Approval of AA1 (B) Plan

This approval refers to Action Area Plan 1(B), as defined in the Wicklow Environs & Rathnew Local Area Plan 2008-2014, submitted on the 18th December 2009 by PD Lane & Associates on behalf of Crackington Ltd. The submitted Urban Framework Plan is taken as forming part of the submitted action area plan for the purposes of this approval.

Approval of Urban Framework Plan for AA1 (B)

Re: **ACTION AREA PLAN 1 (B) LANDS AT RATHNEW COUNTY WICKLOW.**

AA1 (b) DETAIL PLAN DEC '09

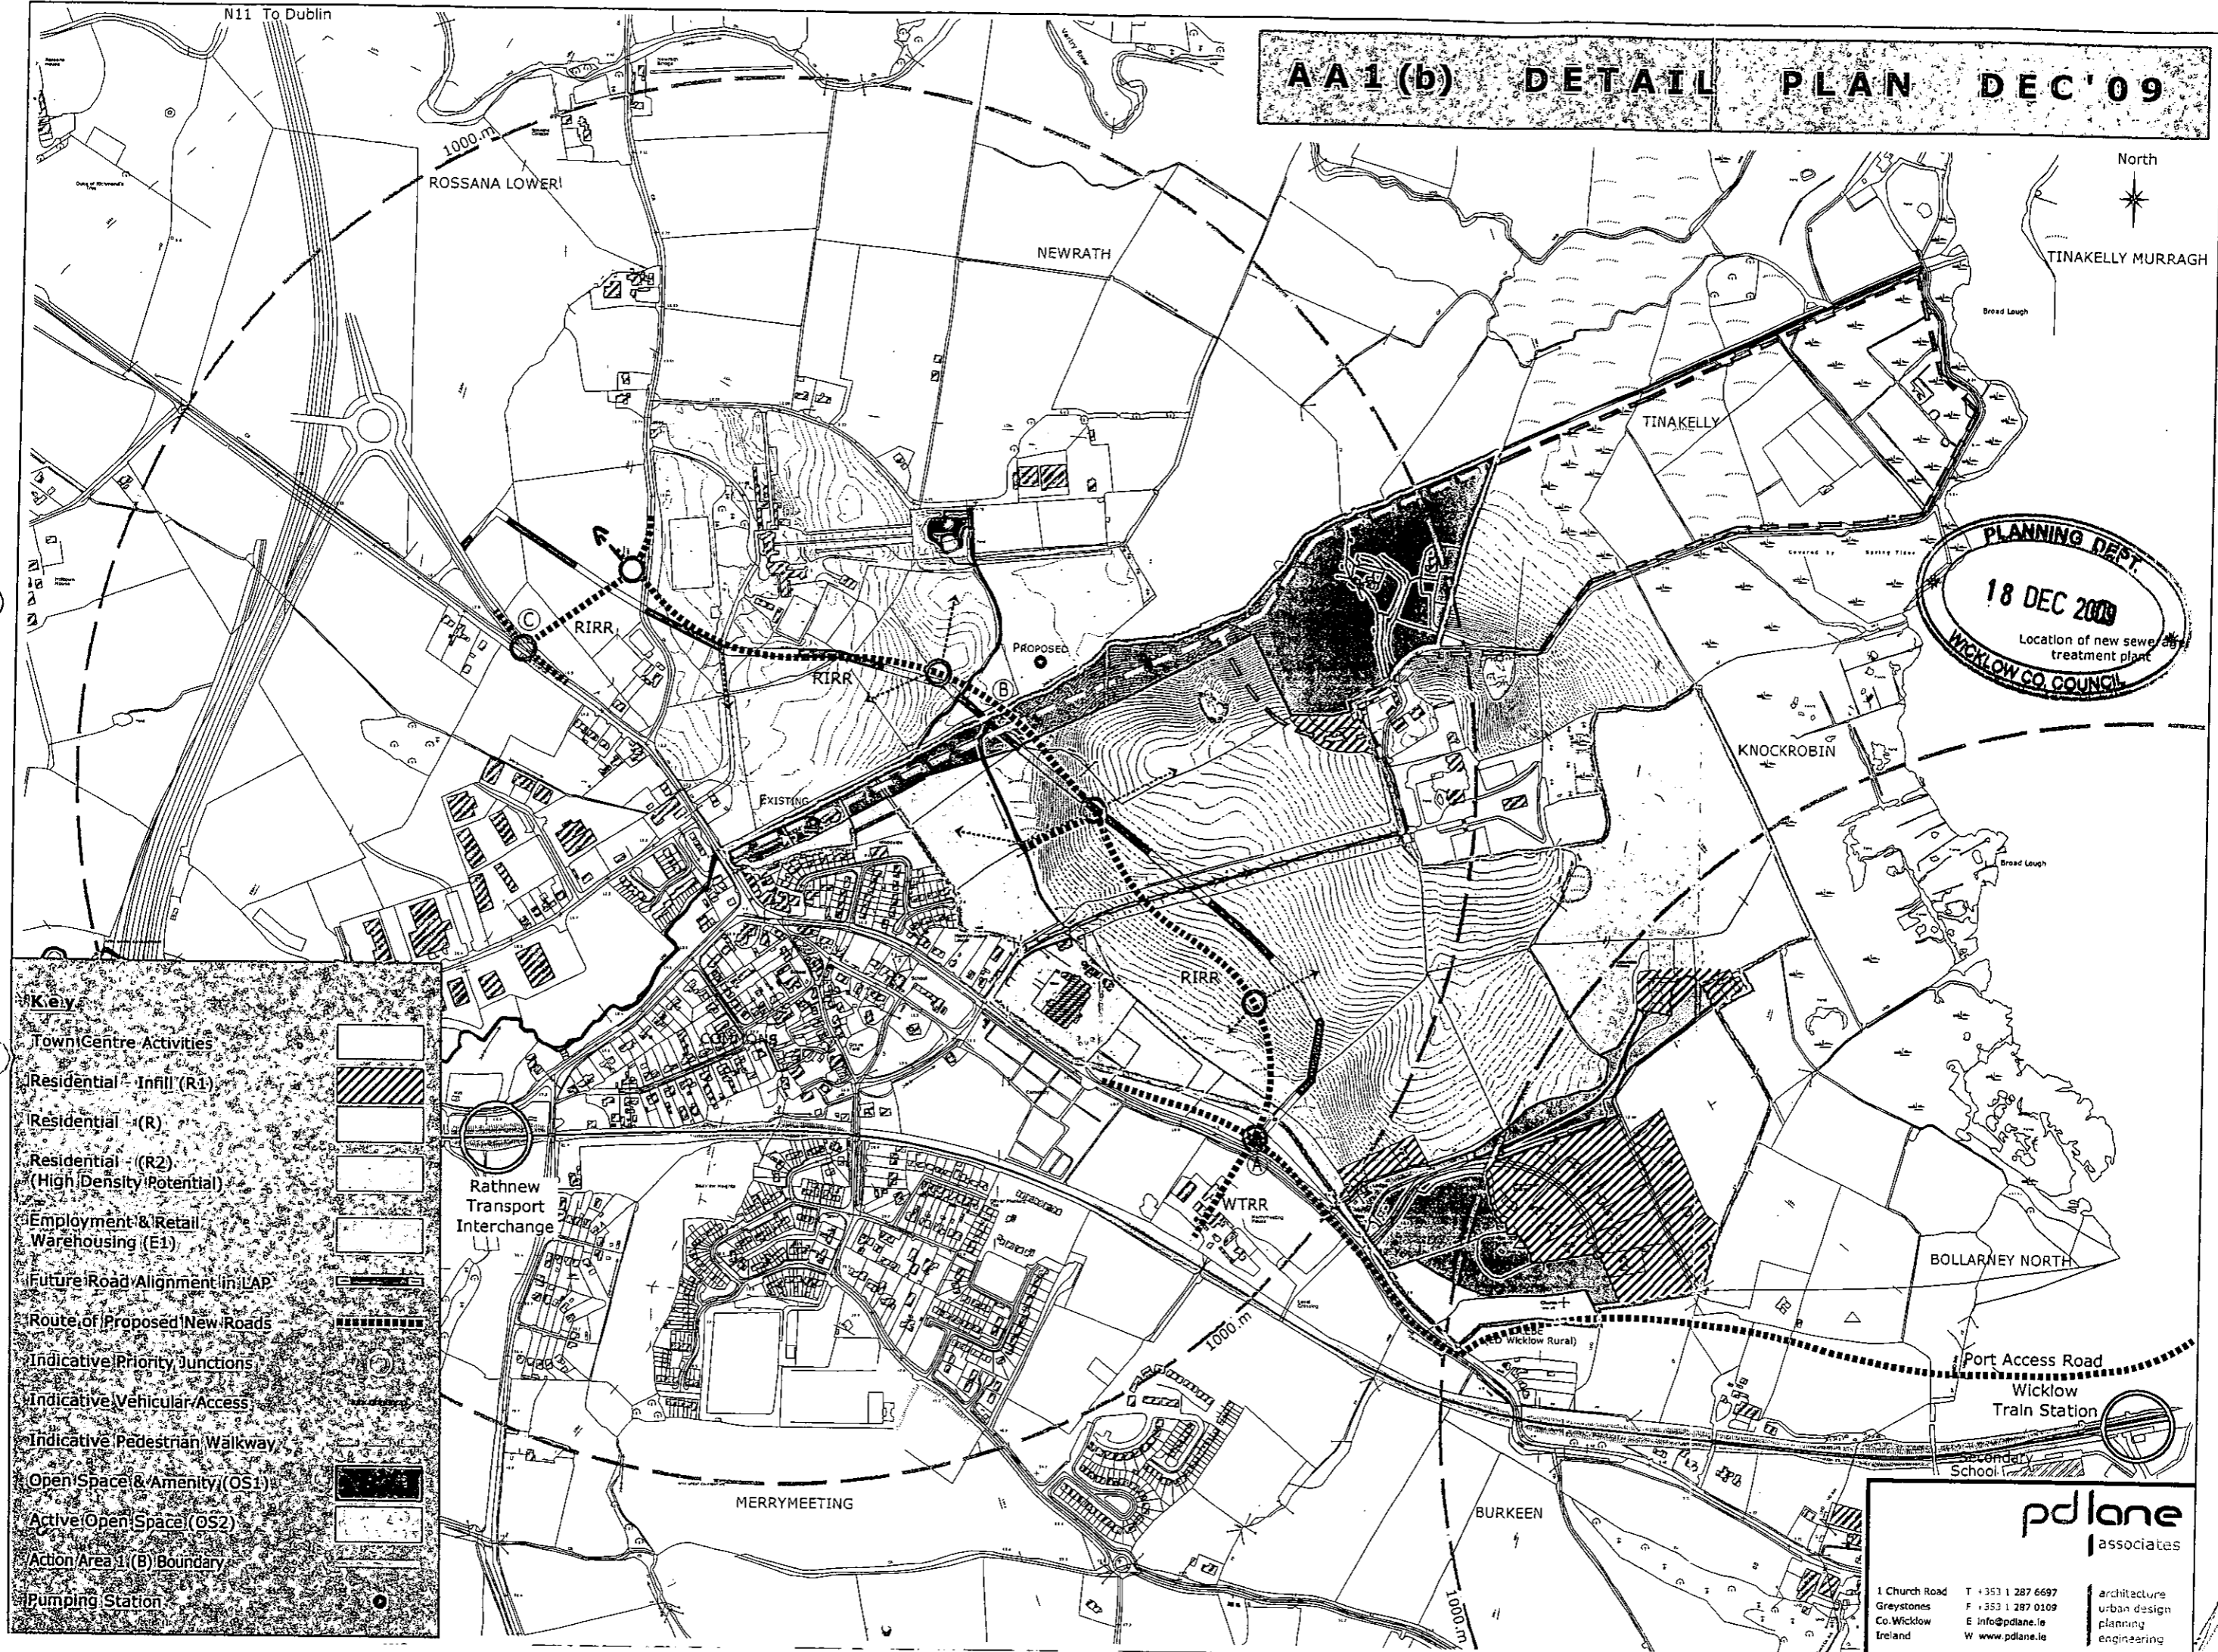
- Section 4 entitled 'Infrastructure, Services and Transportation' should be amended to include reference to the potential access from Main Street to the Claremont Holdings lands;
- The Draft AAP1(B) Detail Plan should be amended to indicate the potential for access from Main Street to the Claremont Holdings lands;
- The Draft AAP1(B) should outline that any residential development within the AAP1(B) area which does not rely upon the RIRR for access, will not be subject to the restriction of the Wicklow / Rathnew Local Area Plan which states that "only 40% of residential development will be permitted in advance of the full completion of . . ." the RIRR.
